CHEVROLET MOTOR DIVISION

Chevrolet Dealer Service Technical Bulletin

67-T-49

Subject: THREE AND FOUR-SPEED FLOOR
SHIFT CONTROL COMPLAINTS
1967 CAMARO

FIGURE 1

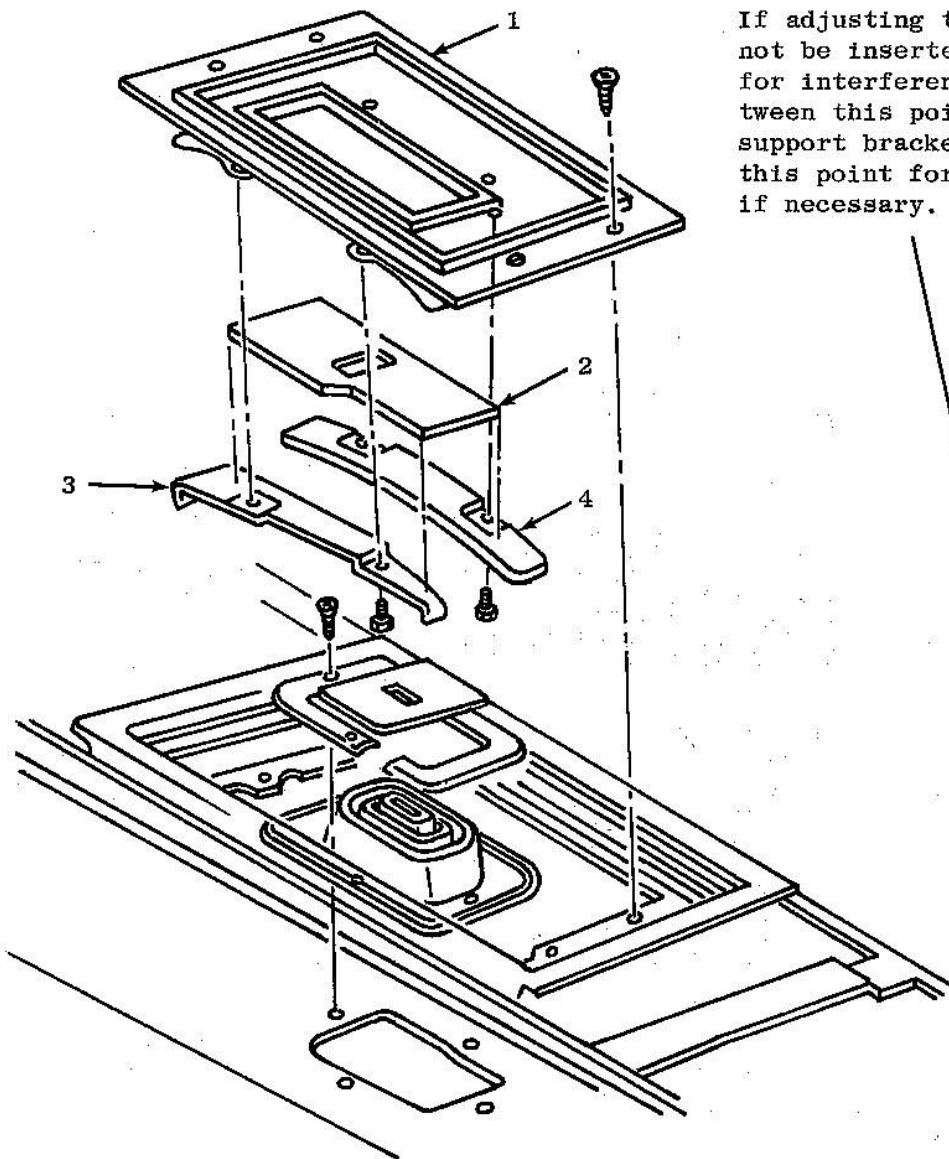
This condition is generally caused by the console shifter plastic slide (see fig. #1, item #2) interfering with the left hand retainer (item #3).

In production, the height of the track was raised to correct the above condition.

For service, remove the plate assembly and examine the underside for interference during operation. If more clearance is needed, add 1/16" washer between the retainer tracks (items #3 and #4) and the plate (item #1). If the slide is too wide, trim off with a file the required amount of material.

If the slide appears to be damaged at the rear edge of the lever opening, the slide may be acting as a stop for the lever. To correct this condition, remove approximately 3/16" from the slide stop or enlarge the opening in the slide.

FIGURE 2

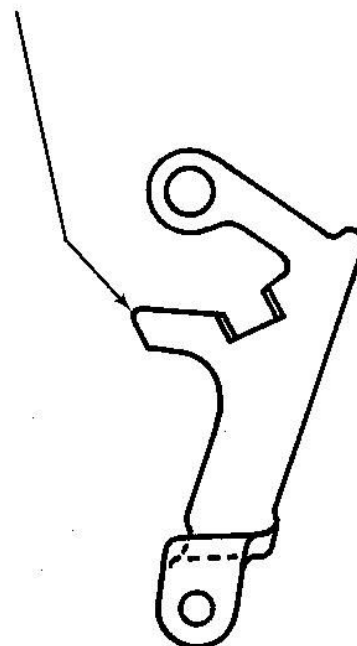
3. Check crossover adjustment - using crossover adjustment tool and procedures, as described in March, 1967, Chevrolet Service News on page 6, check the crossover adjustment. If the tool will not fit (4-speed only), cause may be due to a burr on the front edge of the reverse lever. If the burr is present, remove the lever from the control and grind off the tip of lever (see fig. #2). Make sure all jam nuts and all shift lever bolts are tight.

If adjusting tool can not be inserted, check for interference between this point - and support bracket, grind this point for clearance, if necessary.

FIGURE 3

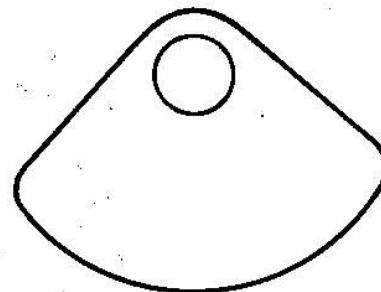
1. Pry off polyurethane retainer and discard.
2. Drive out pivot shaft.
3. Remove levers, wave plate (fig. 3), and lockout plate from bracket (discard wave plate).
4. If reverse inhibitor load is too low, remove plunger and install new plunger (Part No. 3923542) (4-speed only).
5. Inspect shift and control levers for burrs or roughness in gate areas and dress with a stone as required.
6. Lubricate all rubbing surfaces with water resistant grease and reassemble.
7. Install new low load polyurethane retainer (Part No. 3923544).
8. Pry out coil bias spring and discard (4-speeds only).
9. Reinstall control and adjust rods. Be sure to lube rod ends.
